EXHIBIT V.B.1

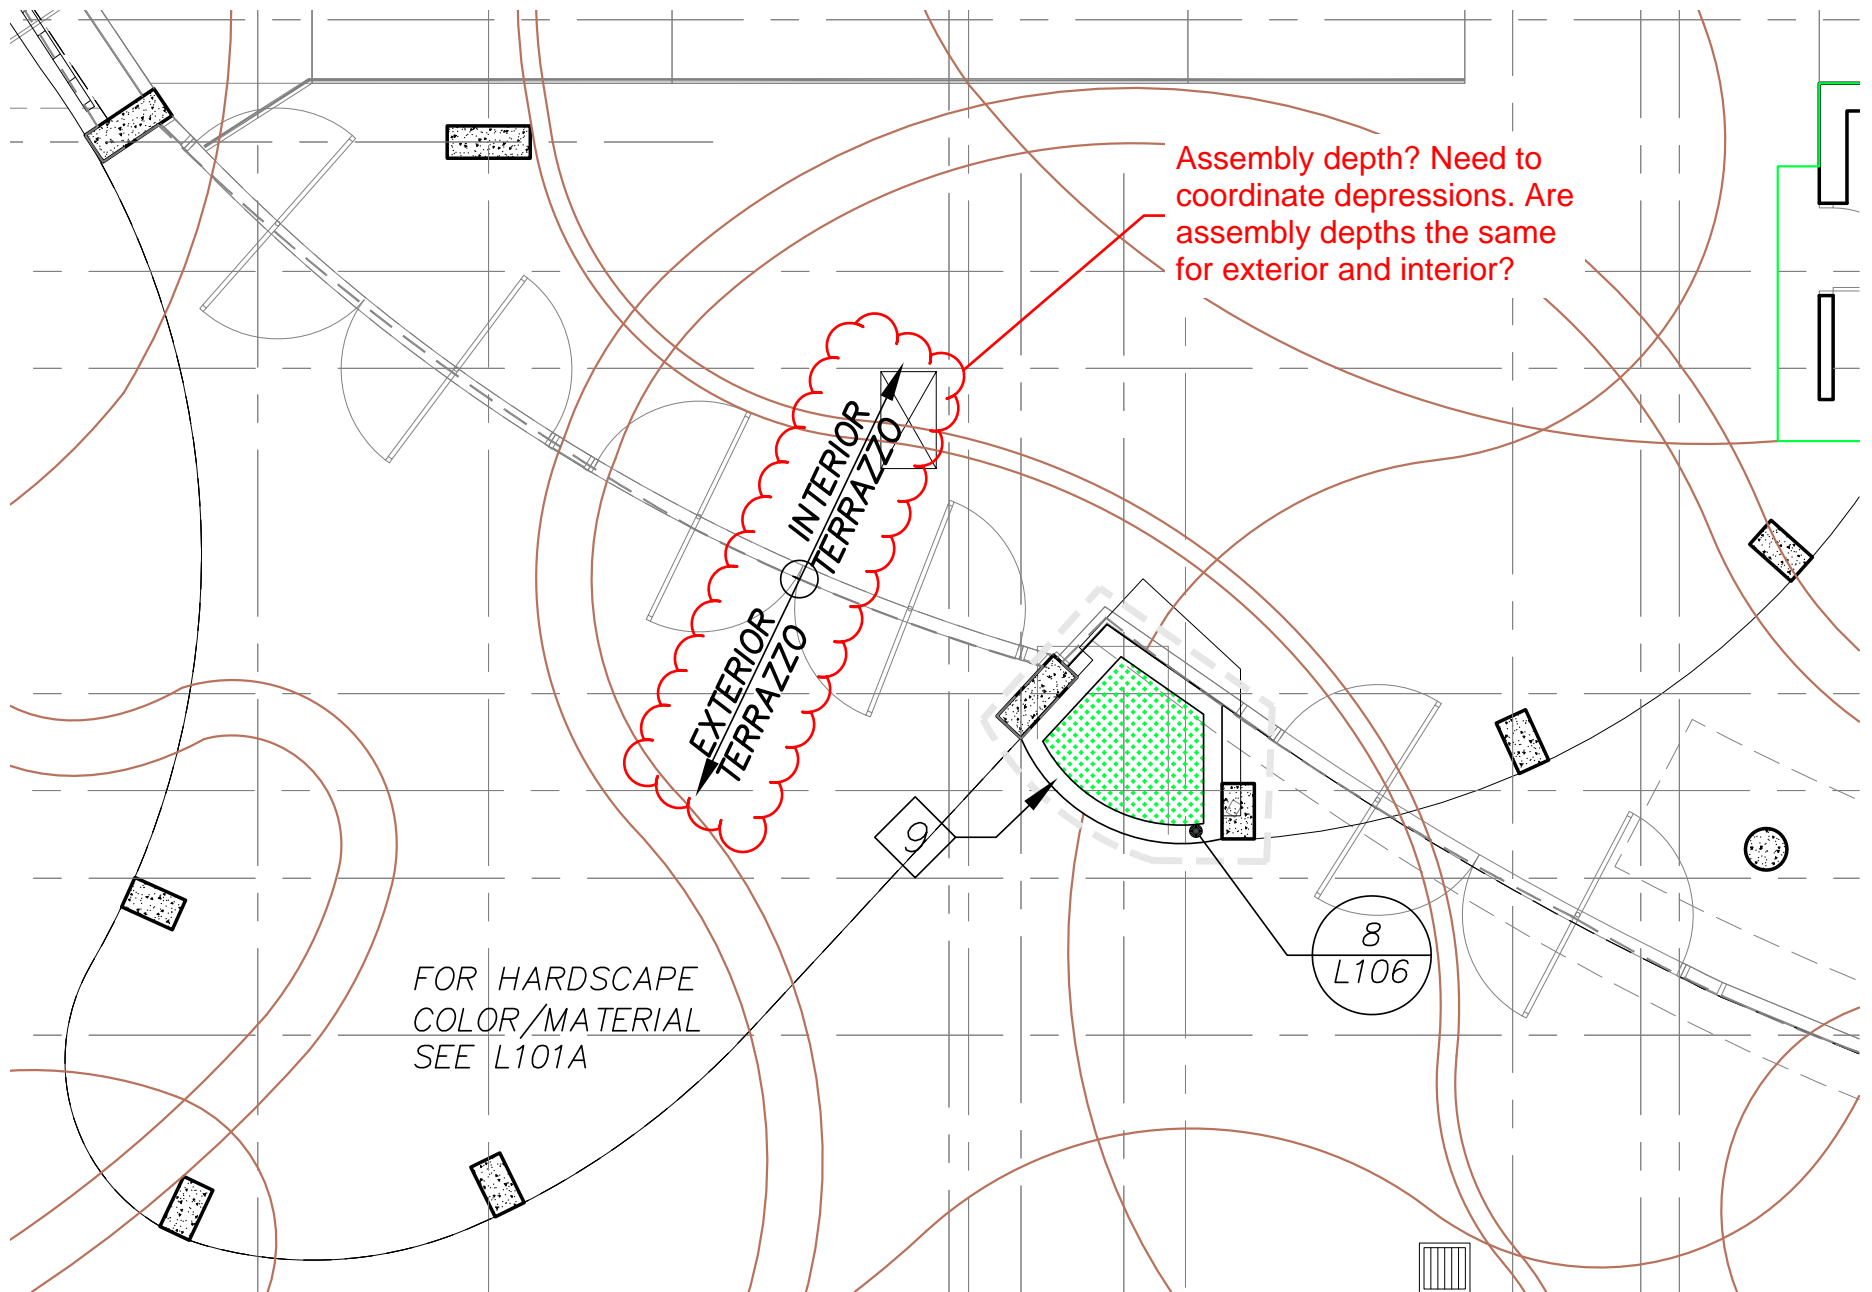
What is this? Plaster? Concrete?  
Precast? GFRC? How many of these  
are there at balconies on the project?  
Need structural details if it is concrete.

## EXHIBIT V.B.4

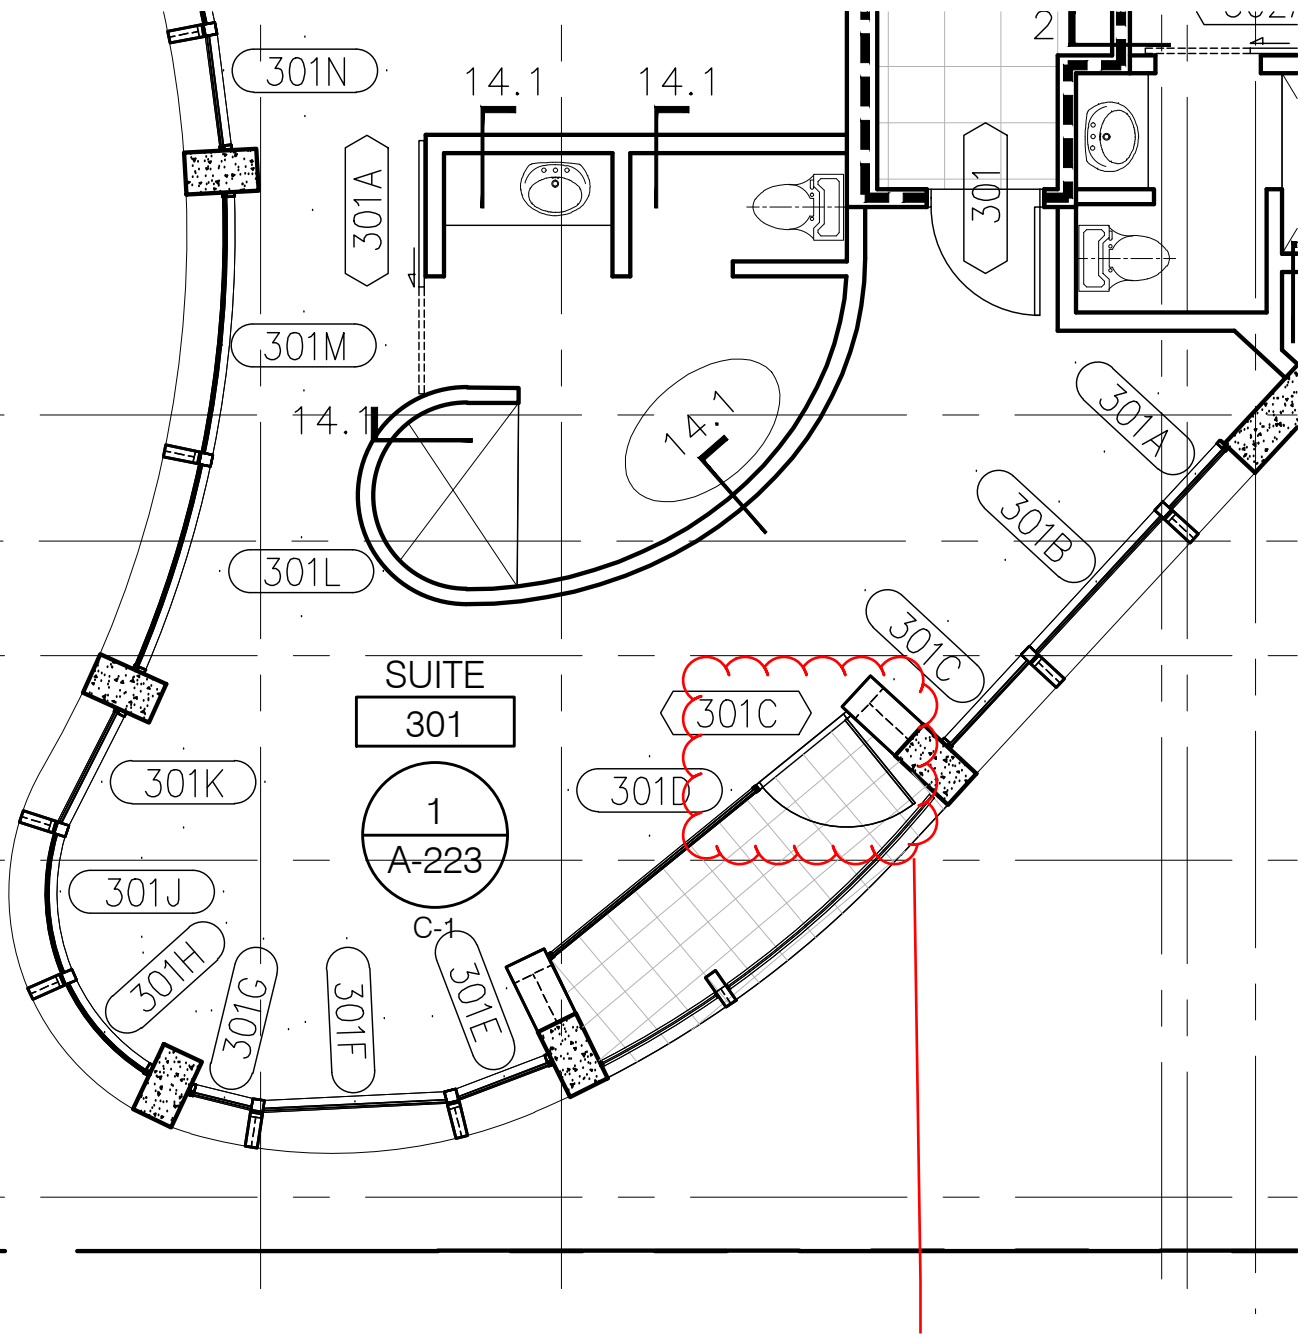
What type of hardware is to be provided at the typical guest room balcony doors? Are closers required as part of the hardware package?

EXHIBIT V.B.5

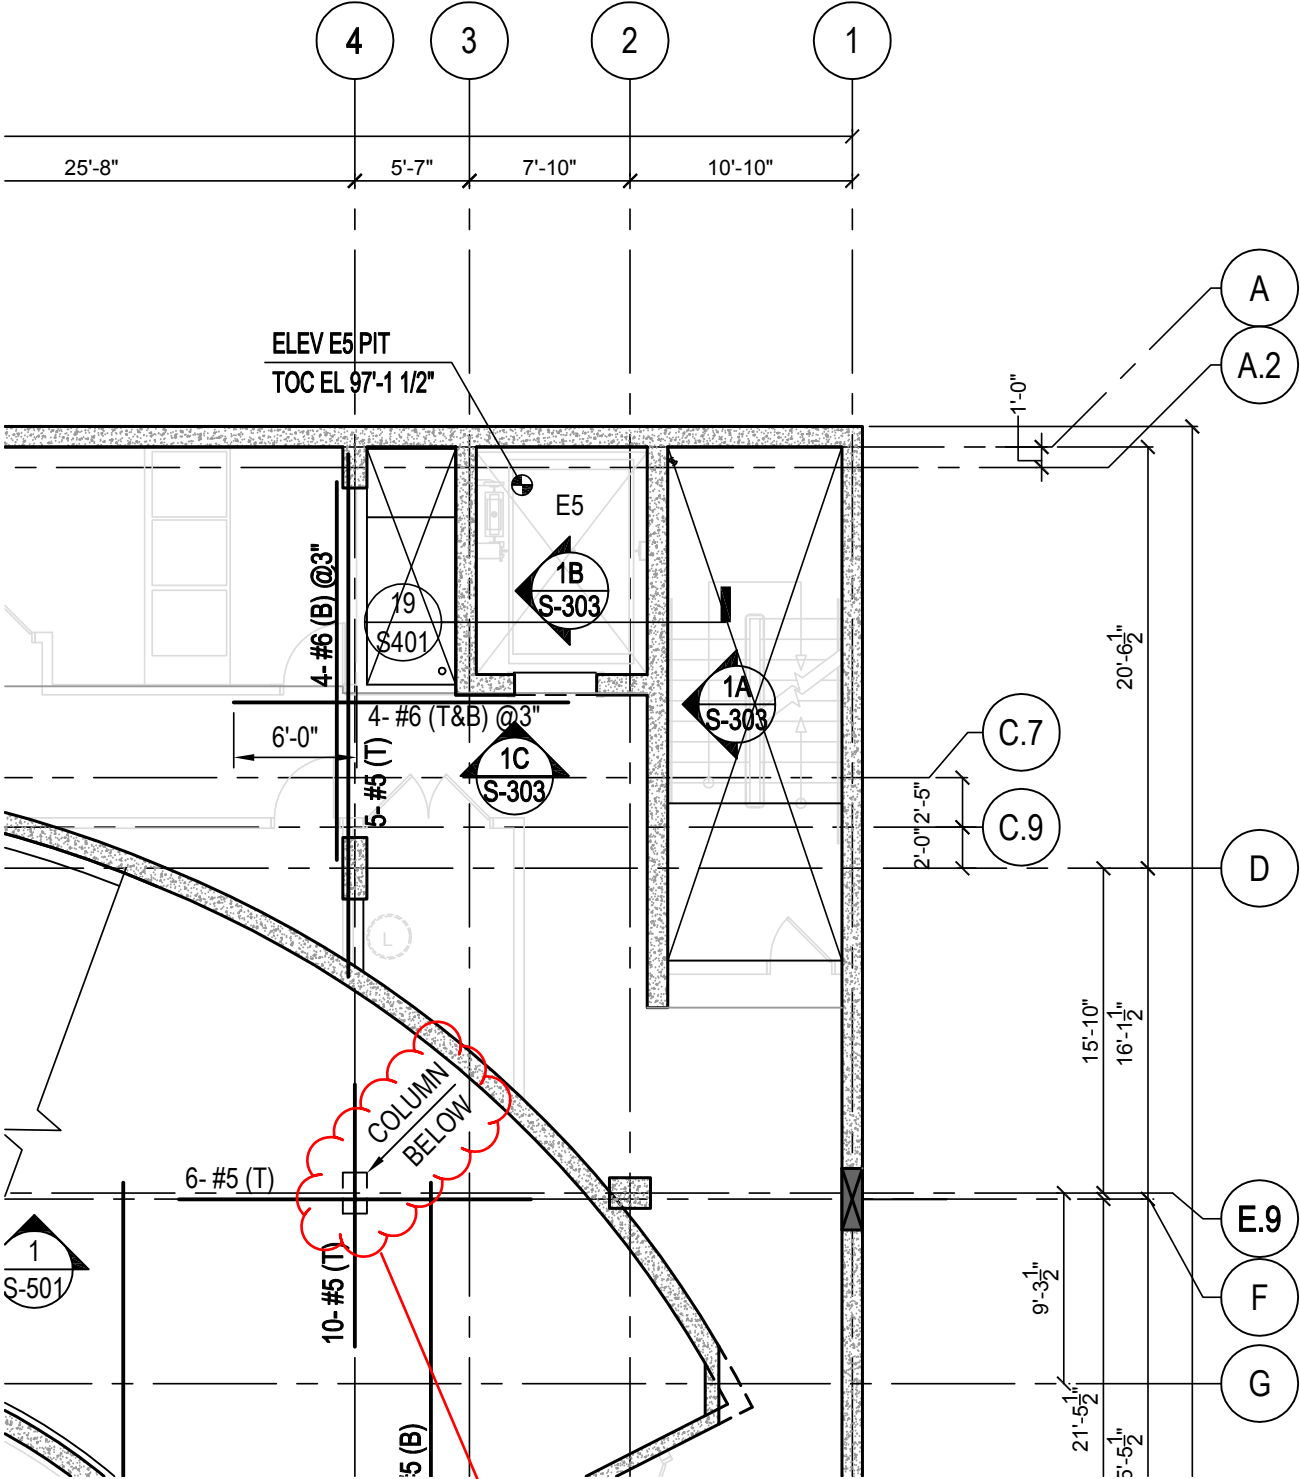
C16 column below P1 Level ramp. The Column Schedule says these should extend up to Ground Floor.

## EXHIBIT V.B.6

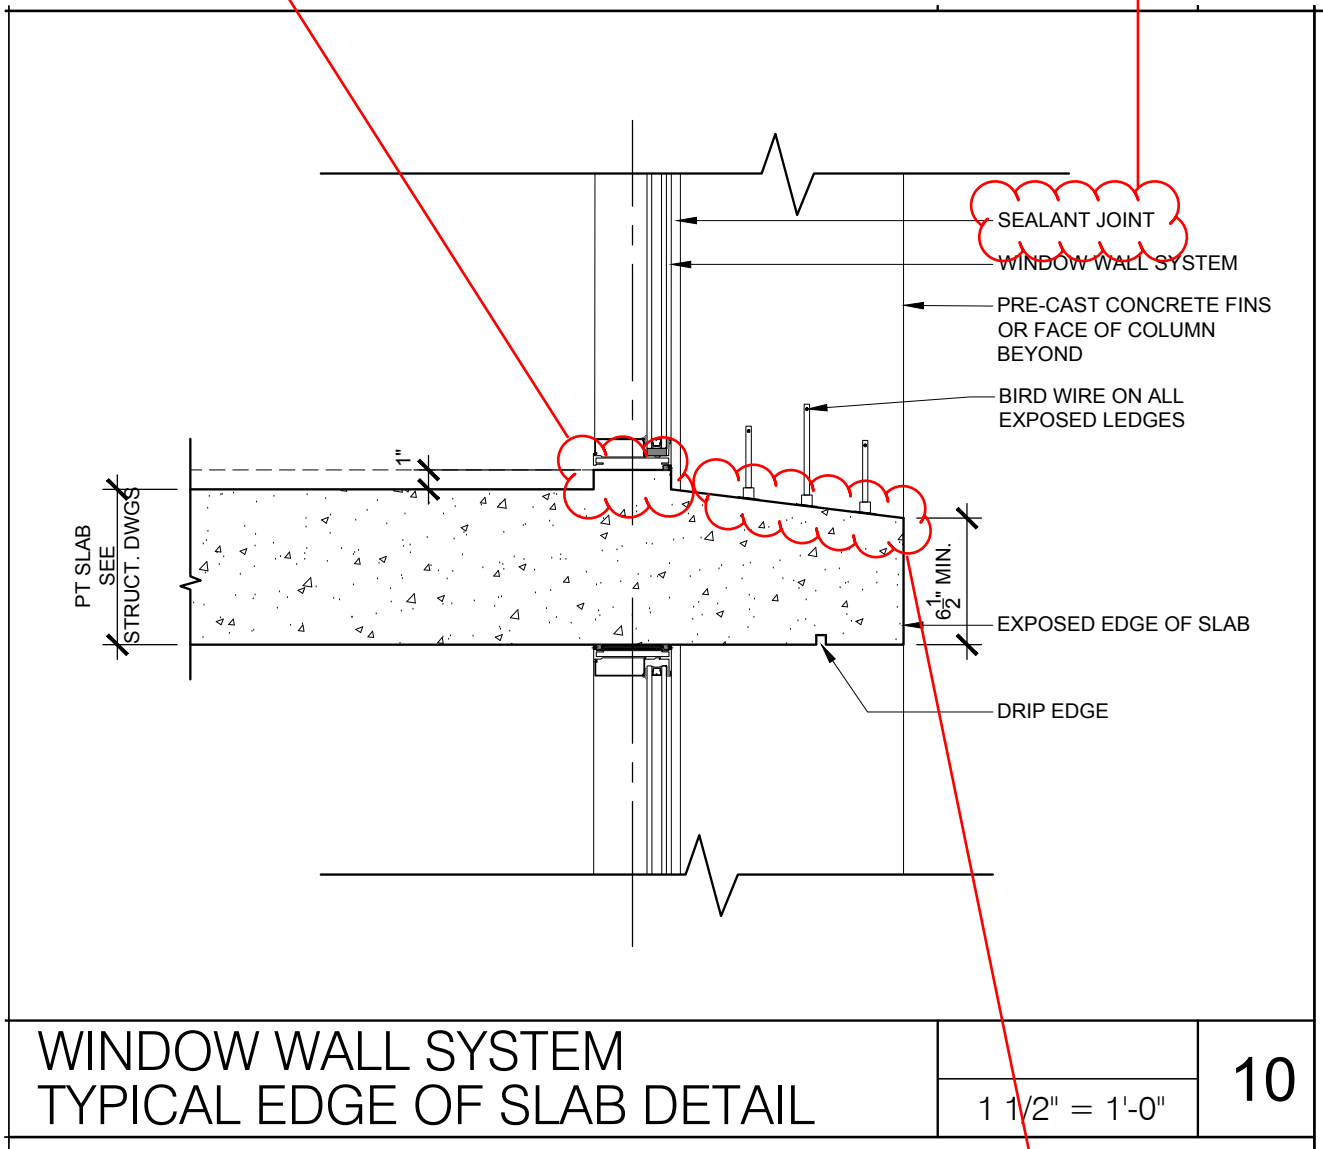
Windows in the Window Wall System are over 9' tall. We need embeds for the windows in these curbs since we cannot post-anchor into the PT deck. What size of embed or structural connection are we supposed to use?

What type of sealant are we supposed to use?

Need caulk joint between fin and slab for construction tolerance.
